**AGENDA**  
**BIRMINGHAM DESIGN REVIEW BOARD**  
**Wednesday - July 6, 2022**  
**BIRMINGHAM CITY HALL, 151 MARTIN ST, COMMISSION ROOM 205, BIRMINGHAM MI \***  
**\*\*\*\*\* 7:15 PM\*\*\*\*\***

**A. 220 Park – Request for façade changes to existing building**

**DATE:** July 6, 2022  
**TO:** Design Review Board  
**FROM:** Nicholas Dupuis, Planning Director  
**SUBJECT:** 220 Park – Design Review

### Exterior Soffit Plan

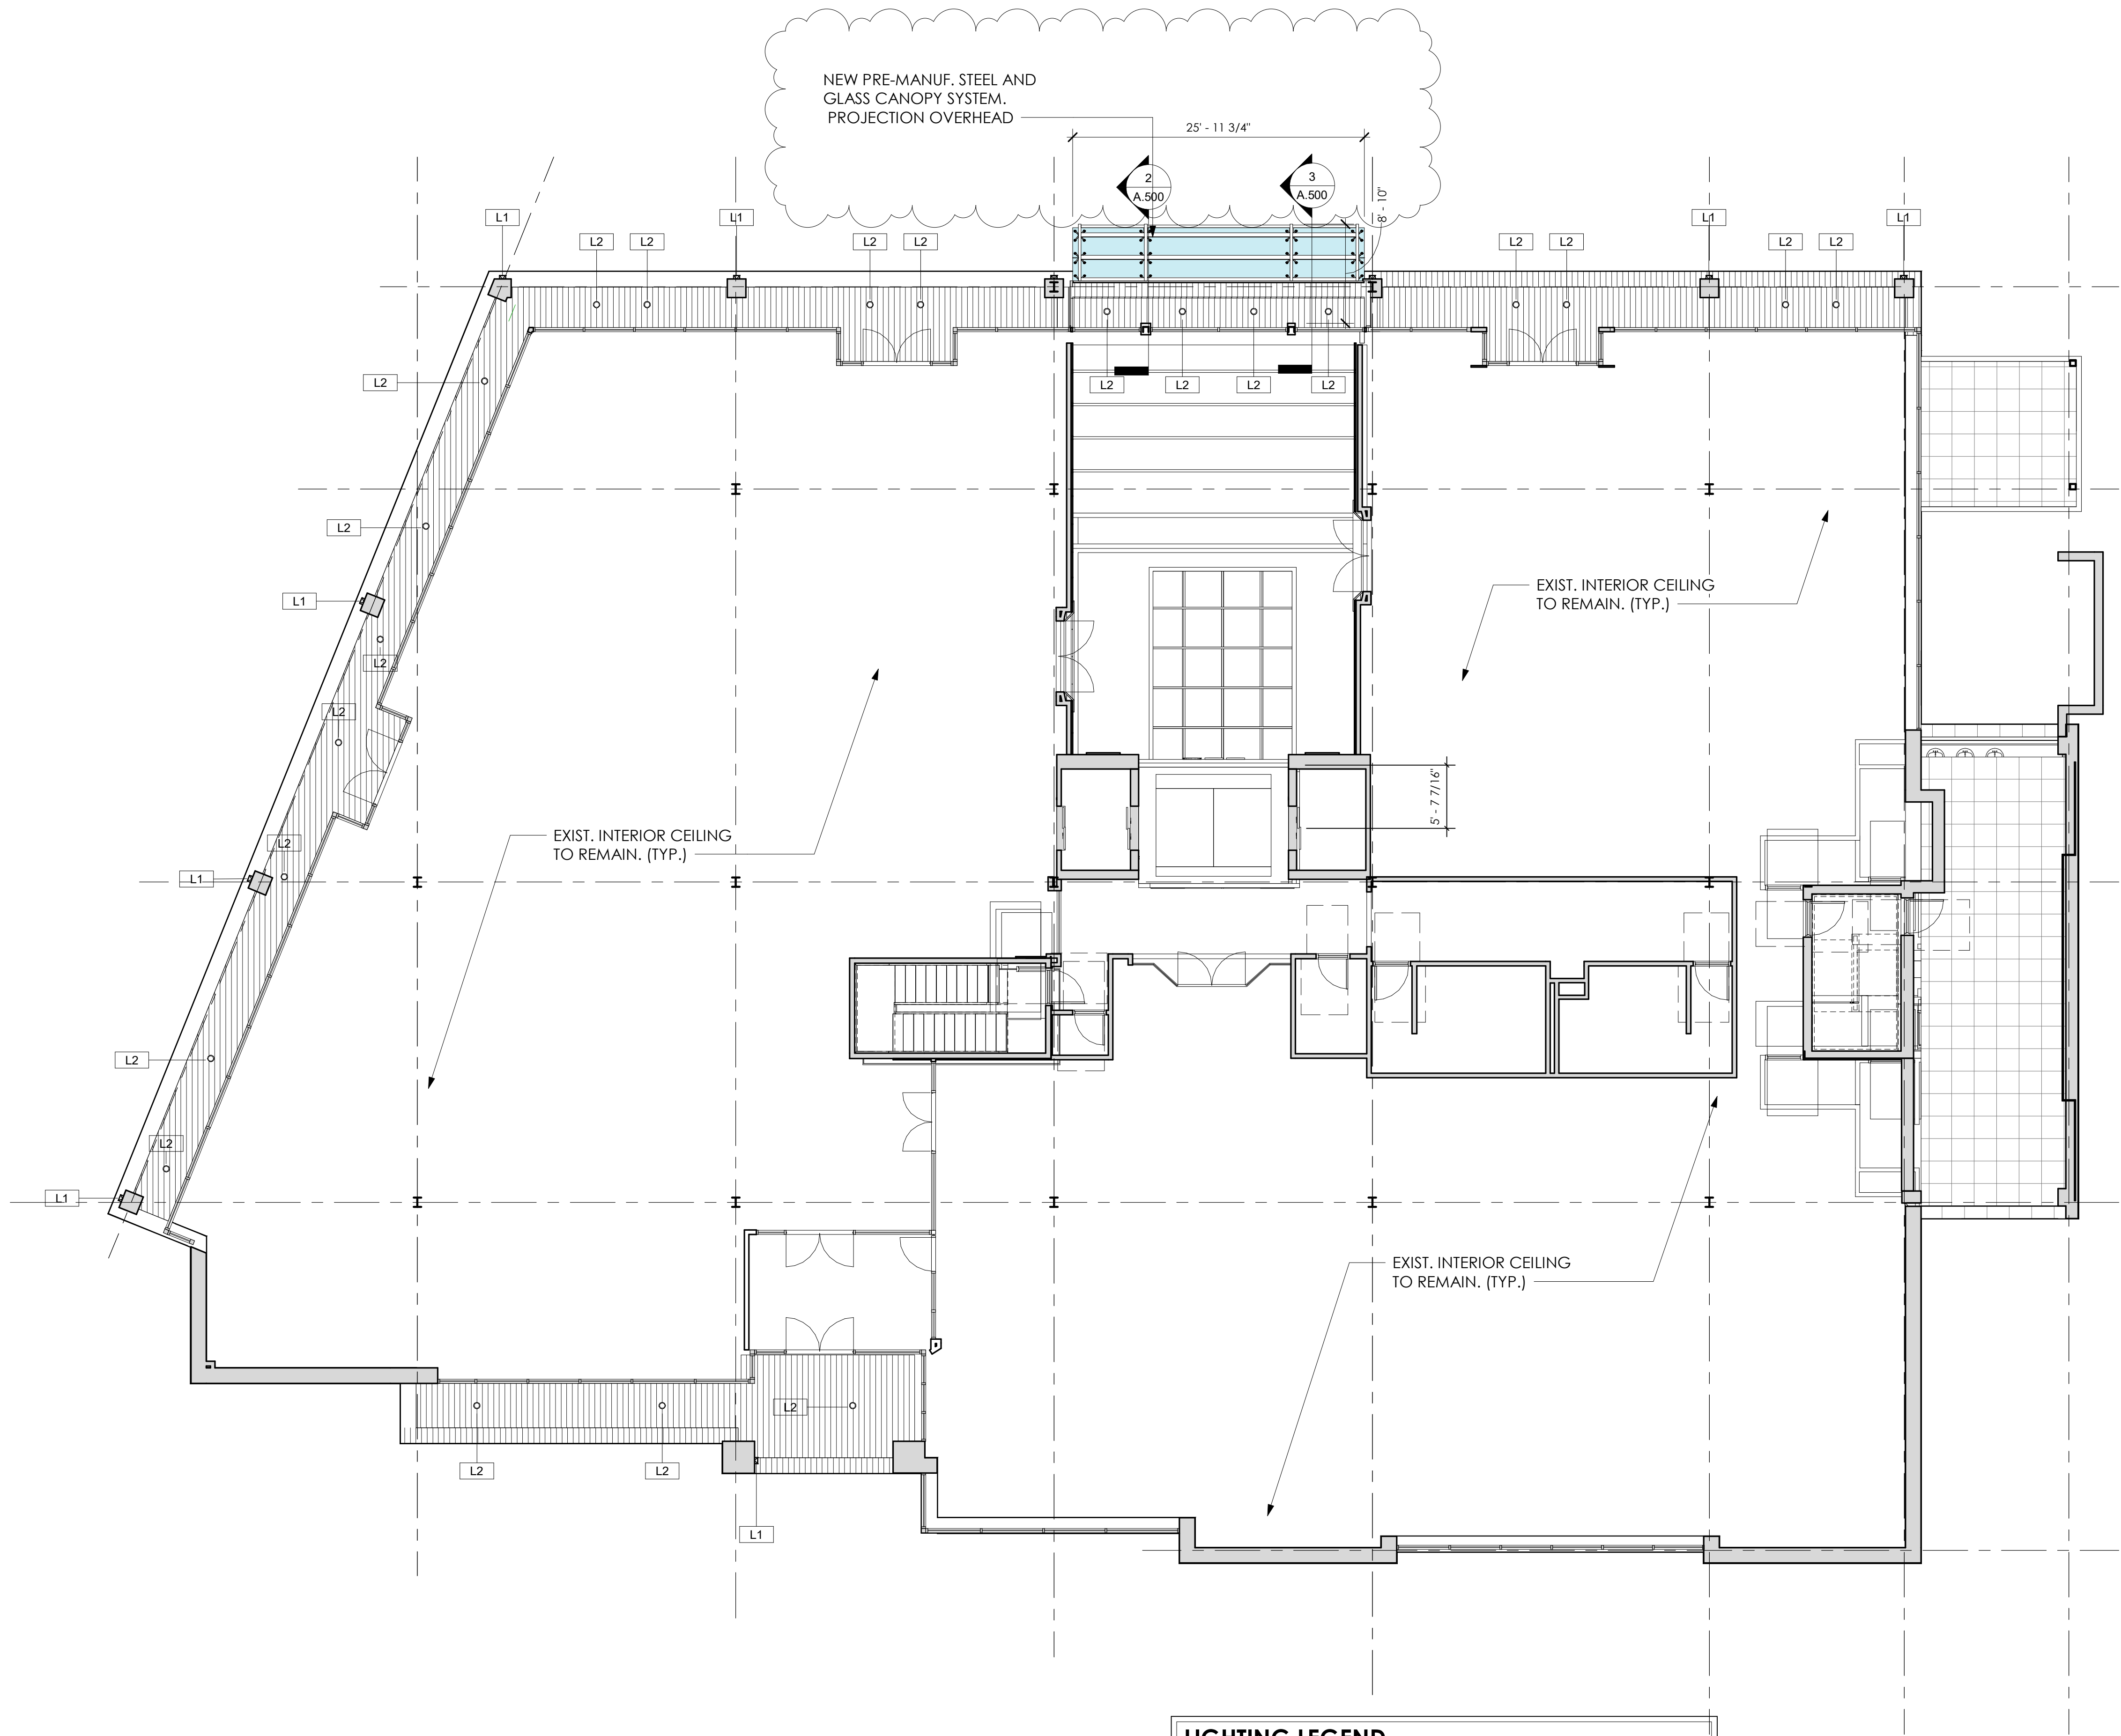
Previously, the applicant submitted plans detailing new fixtures and a photometric plan pursuant to Article 4, Section 4.21(C) of the Zoning Ordinance. During the postponement period, the applicant worked with the Planning Division to better understand the requirements of the lighting standards, and the Planning Division was ultimately advised that the lighting proposals would be removed for the time being until the lighting could be worked out. However, the plans contain notes indicating new light fixtures. **The applicant must remove the new light fixtures from**

**the plans, or submit lighting plans that meet the requirements of Article 4, Section 4.21 of the Zoning Ordinance.**

1. The applicant must remove the lighting from the plans, or submit revised lighting/photometric plans that meet the requirements of Article 4, Section 4.21 of the Zoning Ordinance; and
2. The applicant must submit specification sheets for the proposed glazing.
